PROJECT: Summerlin West v22 - Clowder Pass Way (Street H)

SUBMITTAL: 1st

CITY OF LAS VEGAS		DATE:
INTER-OFFICE MEMORANDUM		December 23, 2019
TO: Land Development Services Department of Building & Safety		FROM: Albert Sung, P.E. Flood Control Project Engineer Department of Public Works
SUBJECT:	Drainage Study for:	COPIES TO:
	Summerlin West V22 - Clowder Pass Way (Street H) (from Desert Foothill Drive to Kettle Ridge Drive <Street J>)	Atkins
Cross Streets:	Desert Foothill Drive & Clowder Pass Way	Howard Hughes Company, LLC
File Number:	F:\Depot\DSMemos\DS5220A.doc	Bart Anderson, P.E., DevCo
Parcel Number:	137-14-401-006, 137-23-101-002	
Zoning Action:	N/A	
FEMA Flood Zone	YES NO X	
Proposed Storm Drain	YES X NO

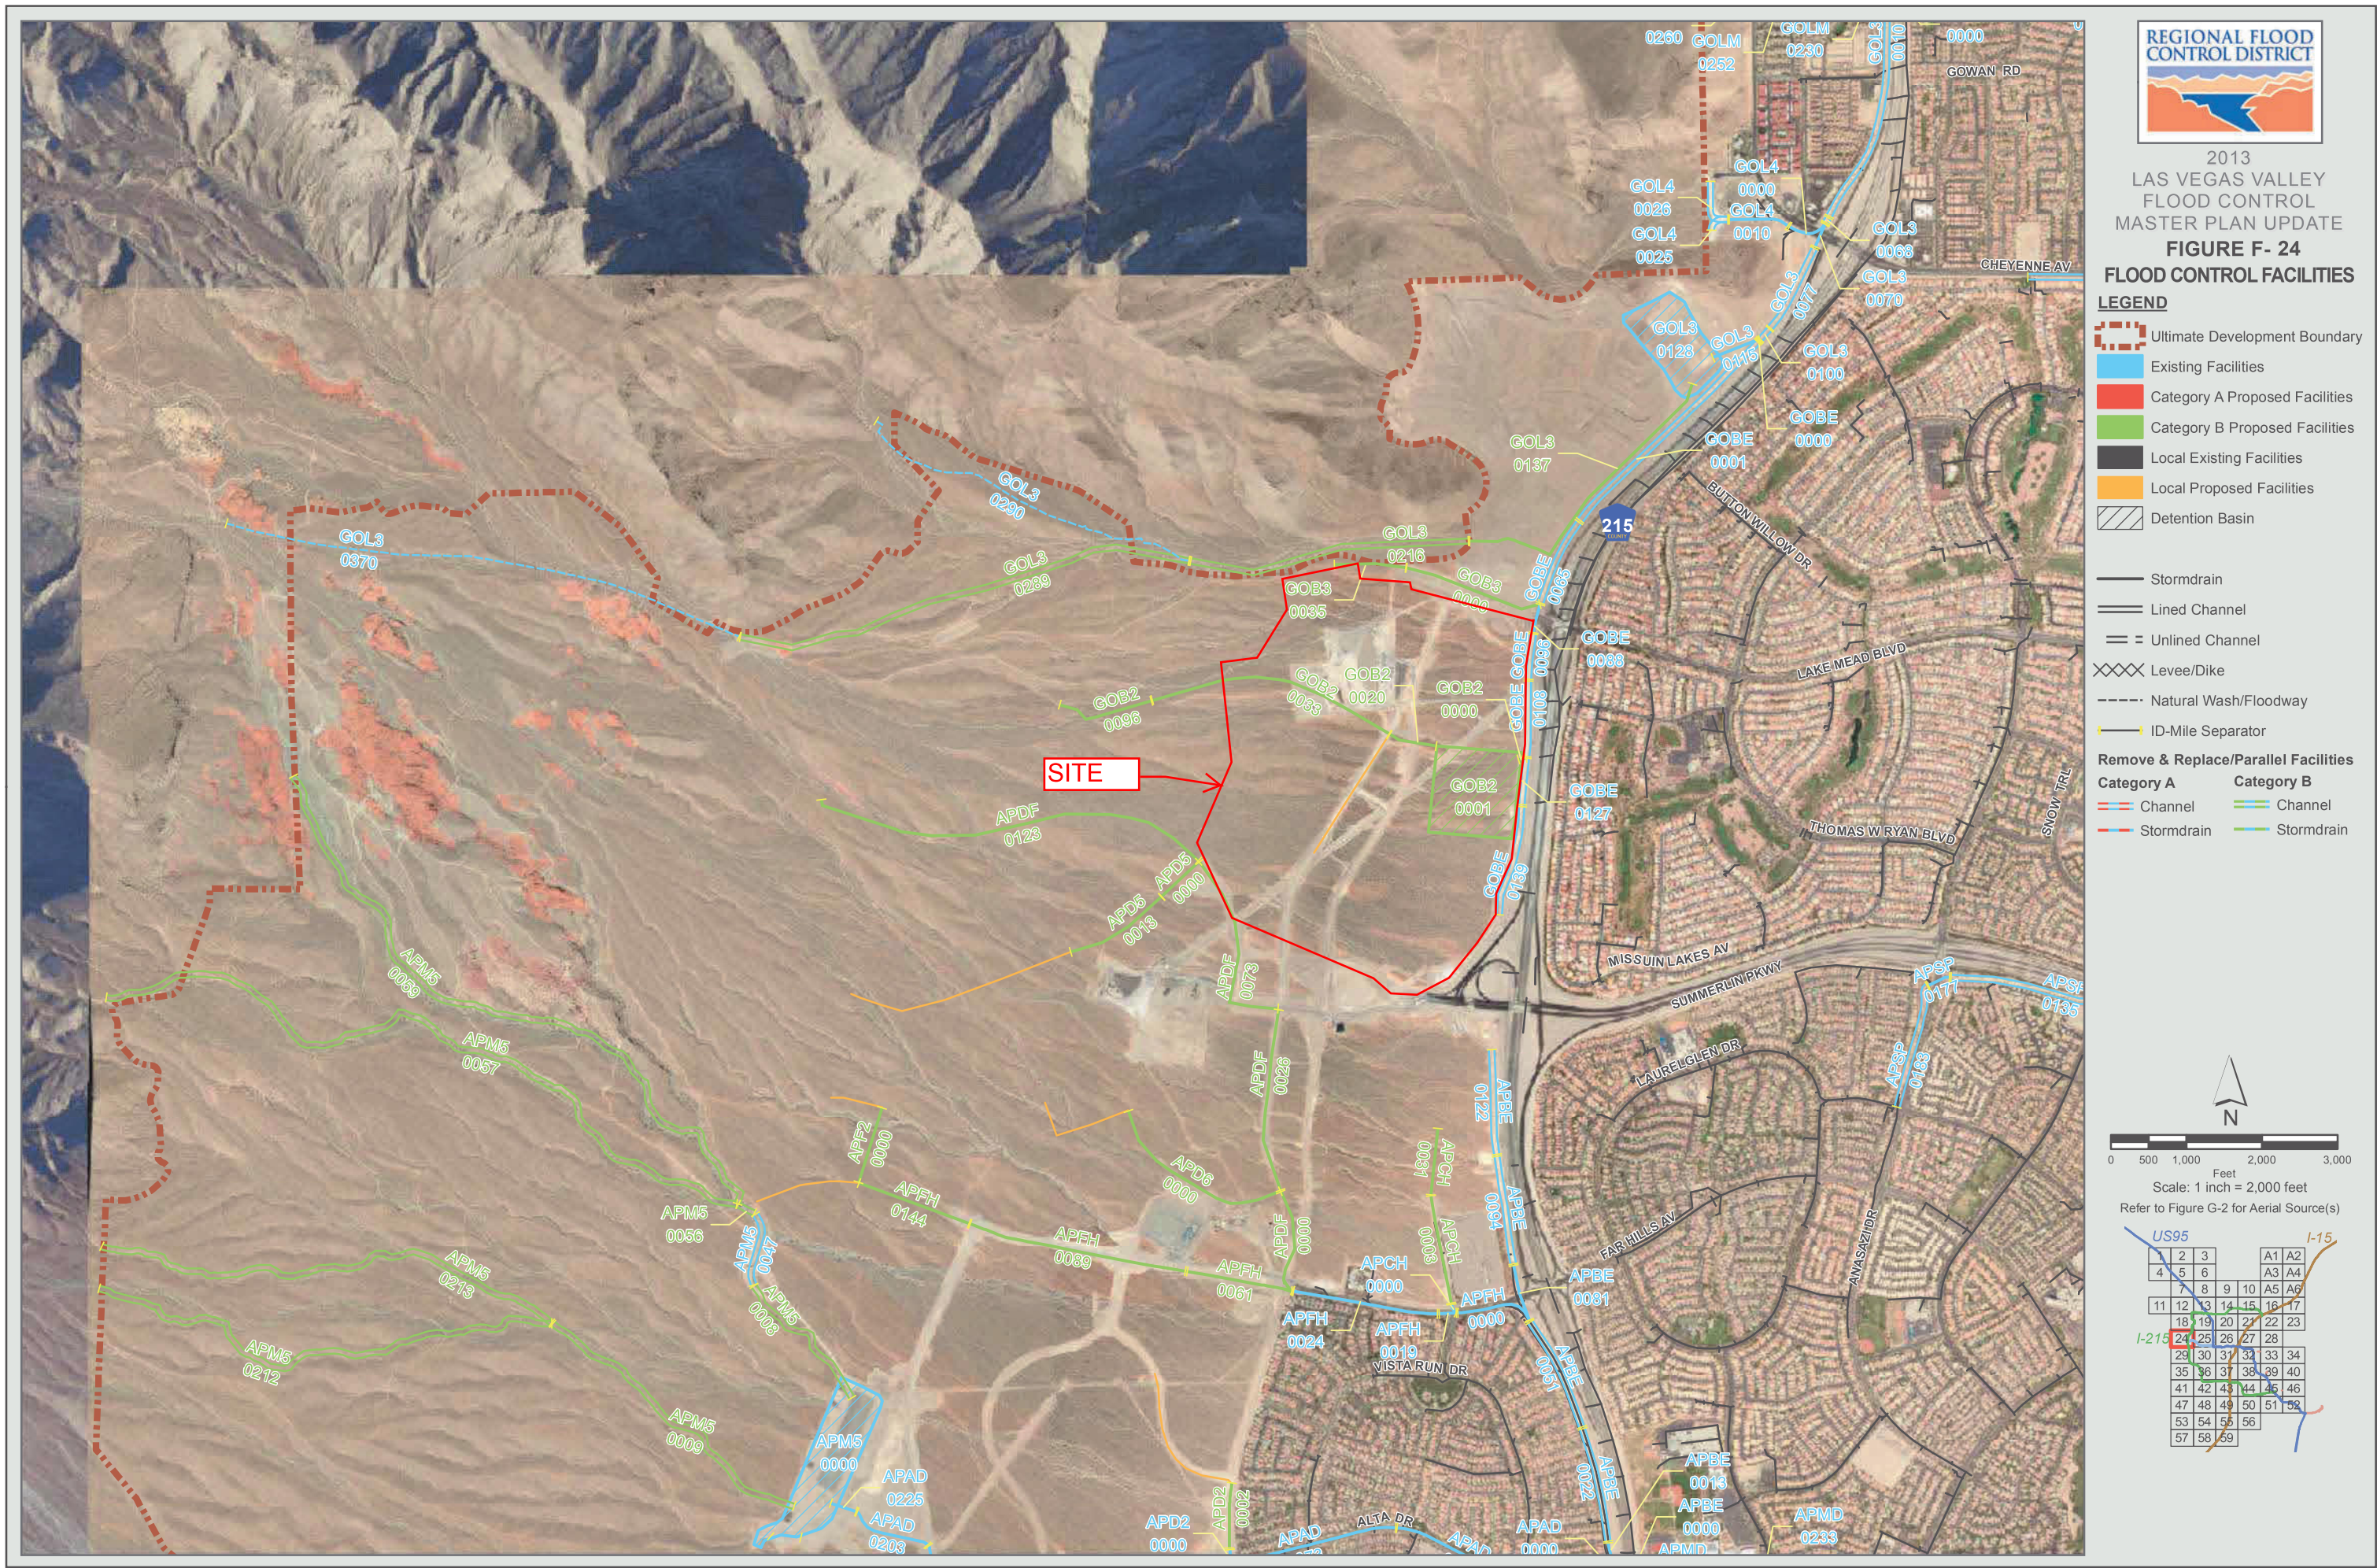
5. SDDI #1 and SDDI #2 are analyzed in Flowmaster with the appropriate flows (2 cfs from STH-1 basin + 0.46 bypass flow from inlets #3 and #4), however Figure 4: Hydraulic Workmap indicates 2.3 cfs going toward the inlets as surface flow. Either explain this further or update accordingly.

JOB NO. 100064083	DESIGNED BY: J. BATES
DATE: NOVEMBER, 2019	DRAWN BY: C. DANIELS
DRAWING NO. 15 / 27	CHECKED BY: P. BATES
CLV 00-00000	HORIZ.: 1"=20'
	VERT.: NONE

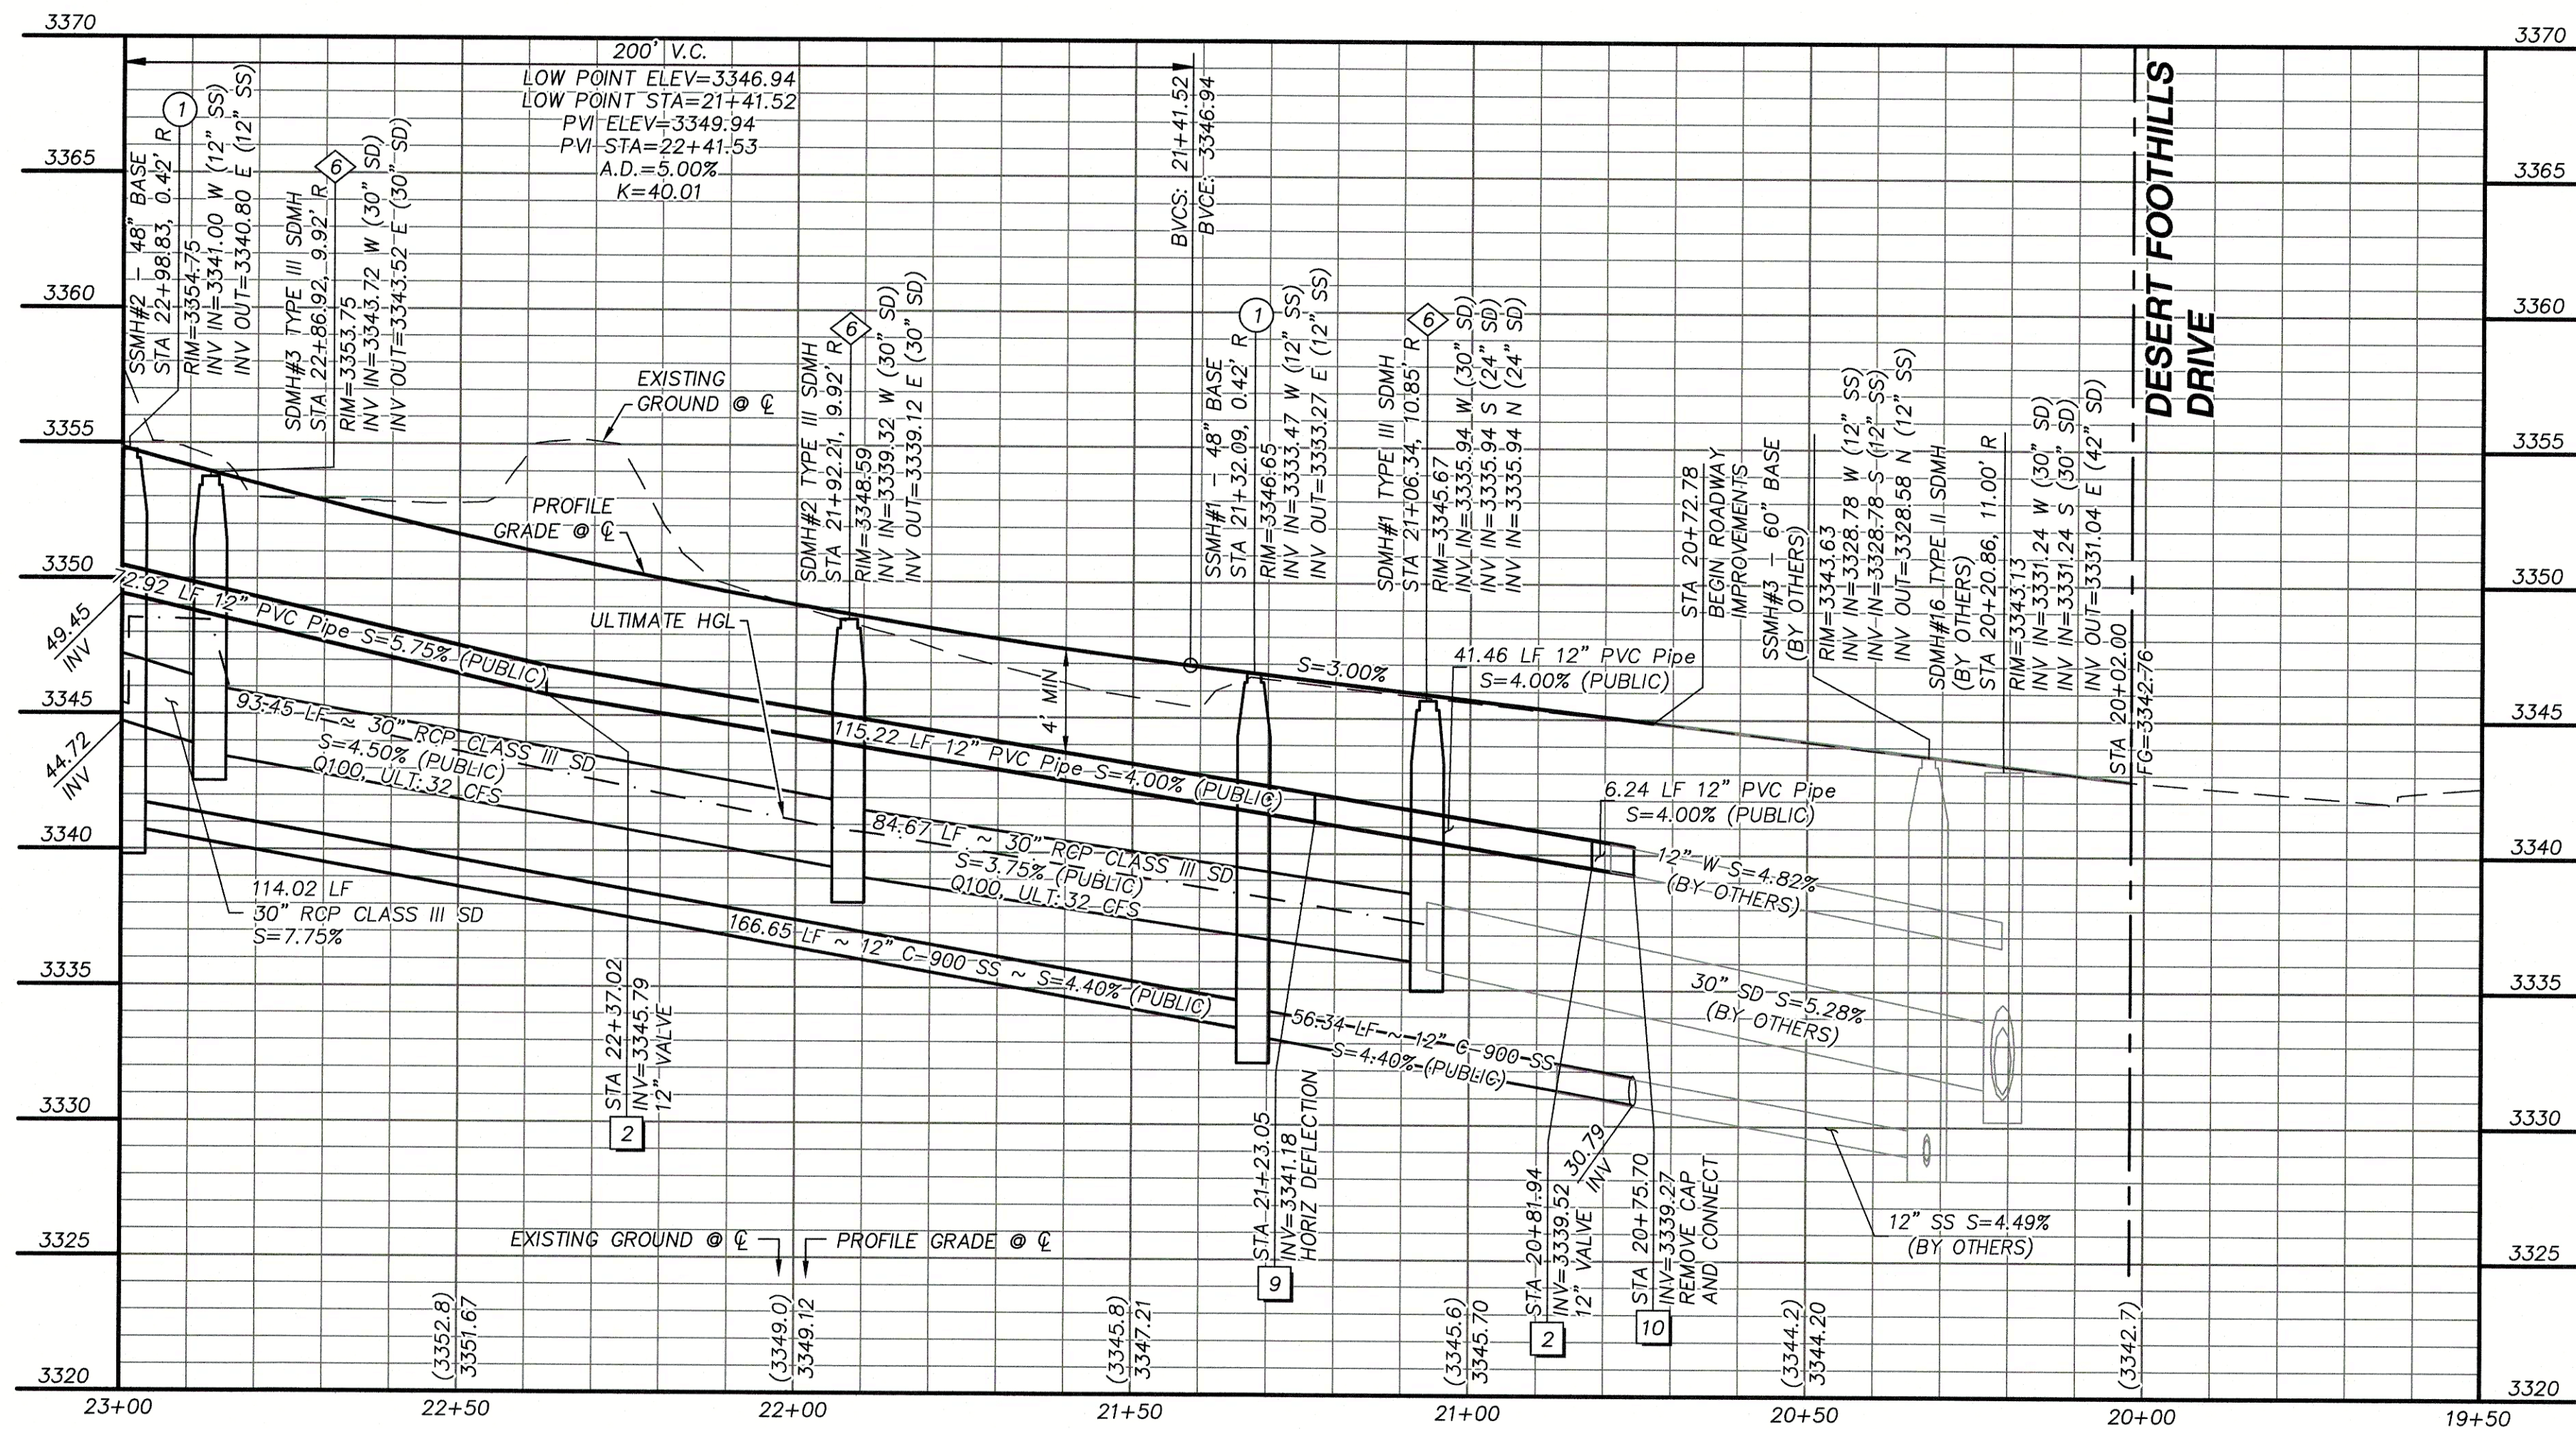
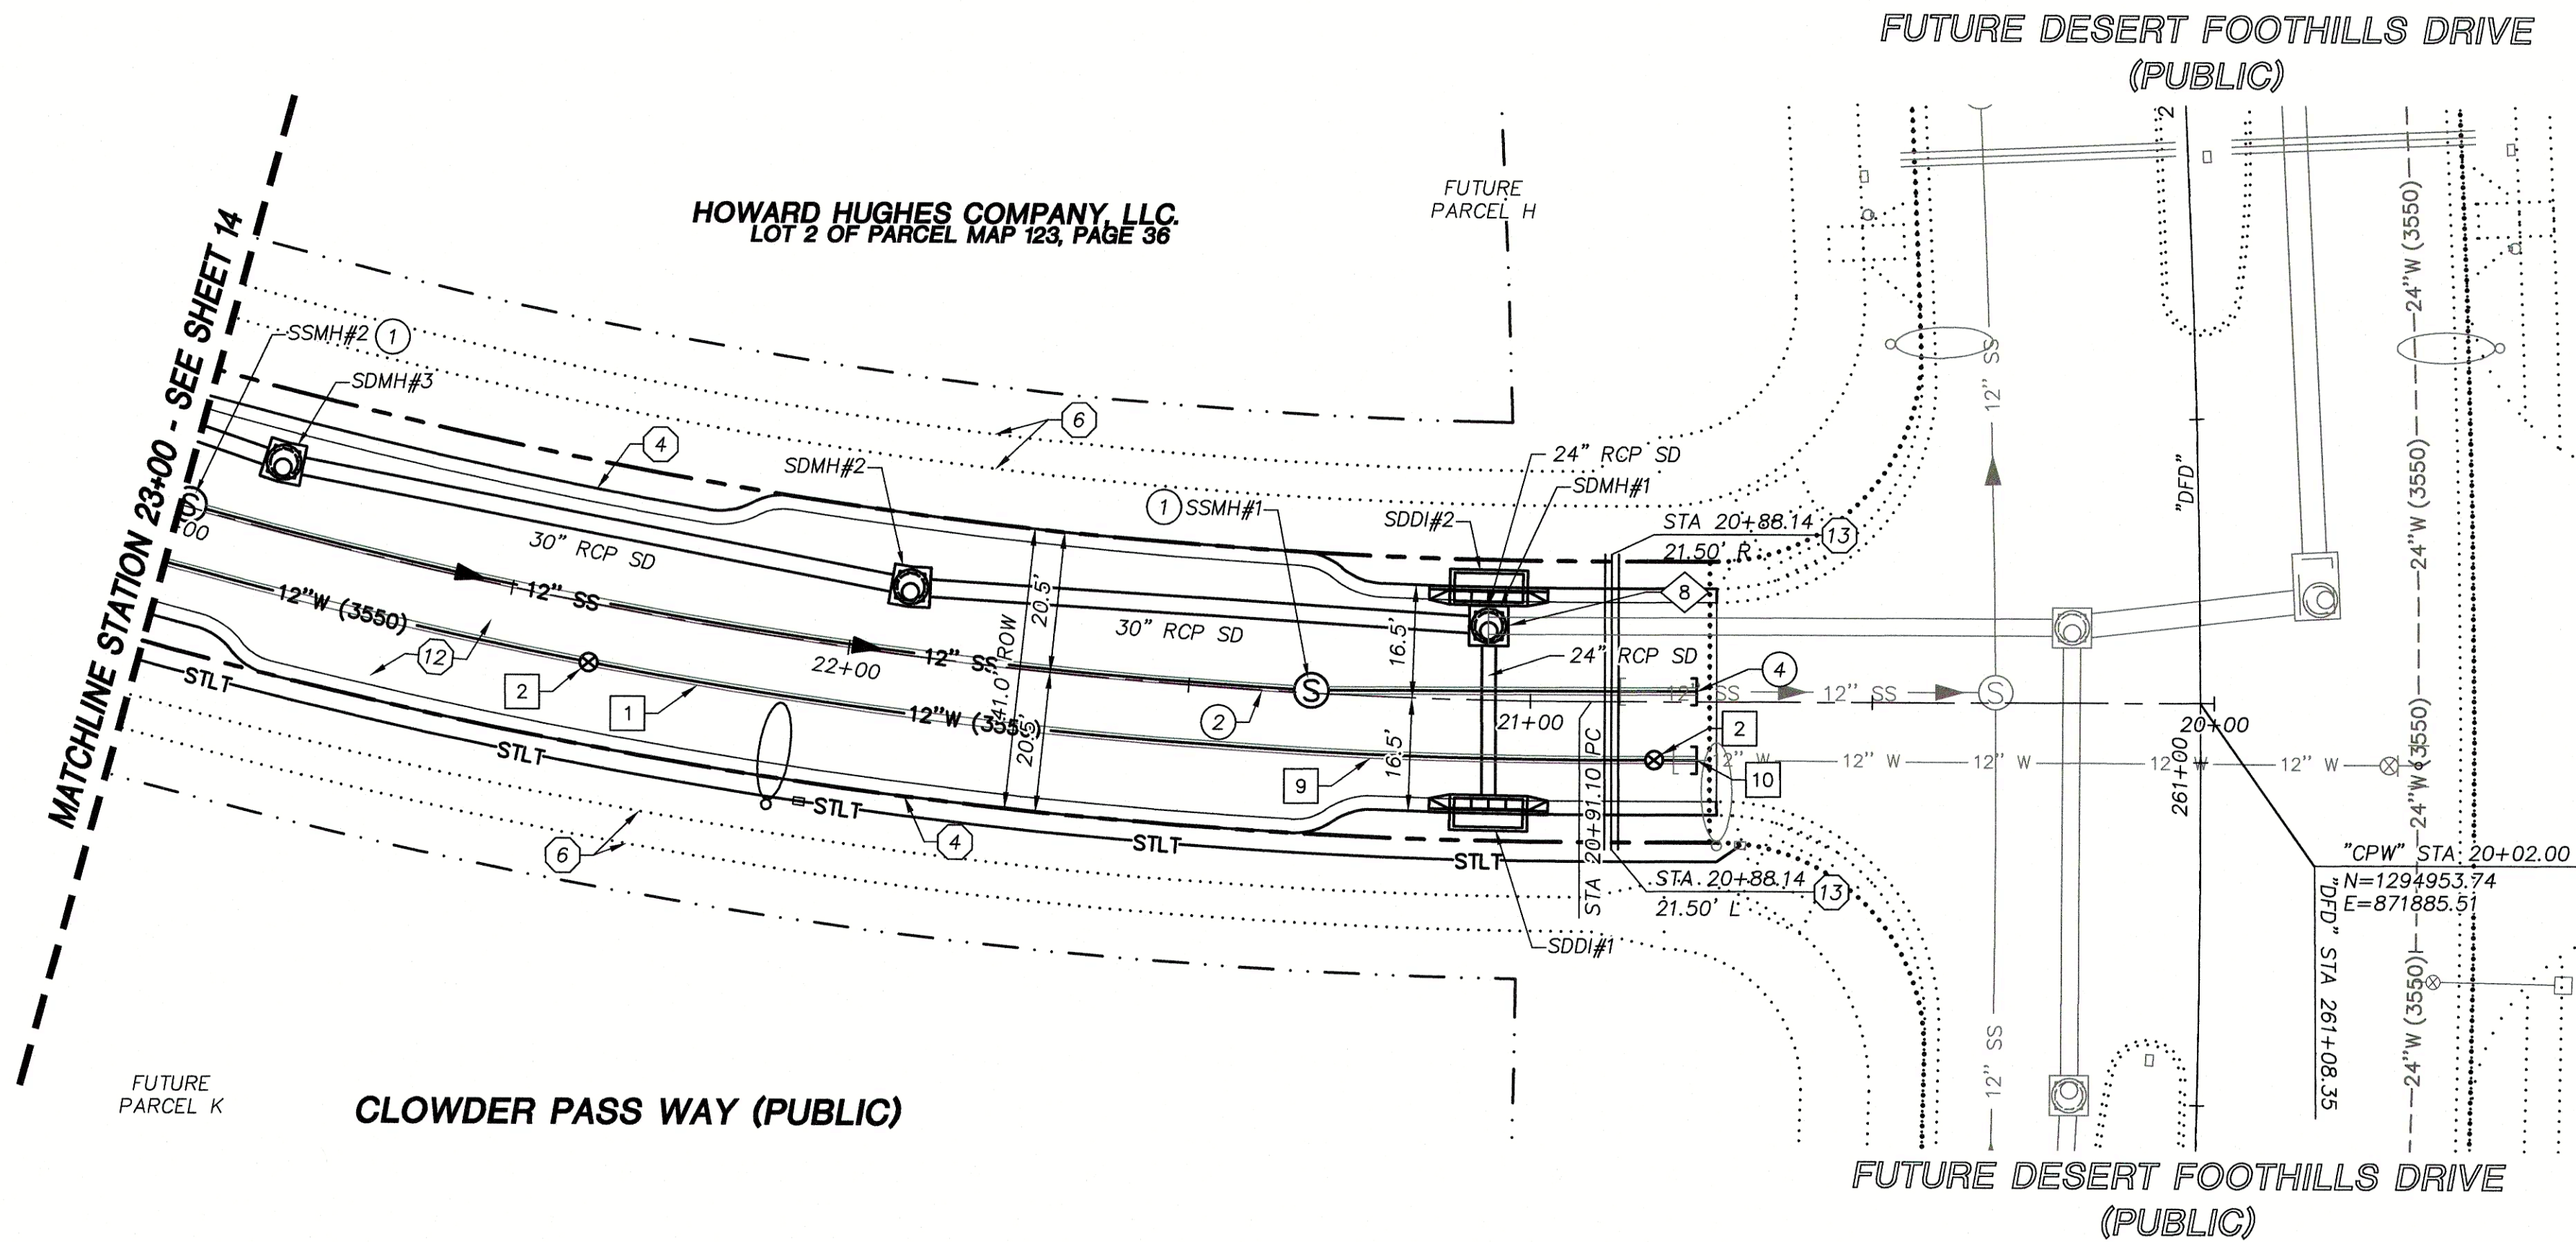
9. **Sheet 15/27** and **Sheet 16/27**: It is assumed that the sequence of construction is that the storm drain system at the intersection of *Desert Foothills Drive* and *Clowder Pass Way* to be installed prior to the subject improvements. Therefore the storm drains downstream of SDMH #1 should be existing in regard to the subject project. Revise the line type of the storm drains in *Desert Foothill Drive* to broken line to reflect "Existing" status and revise the word "FUTURE" Desert Foothill Drive to "EXISTING" in the next submittal.
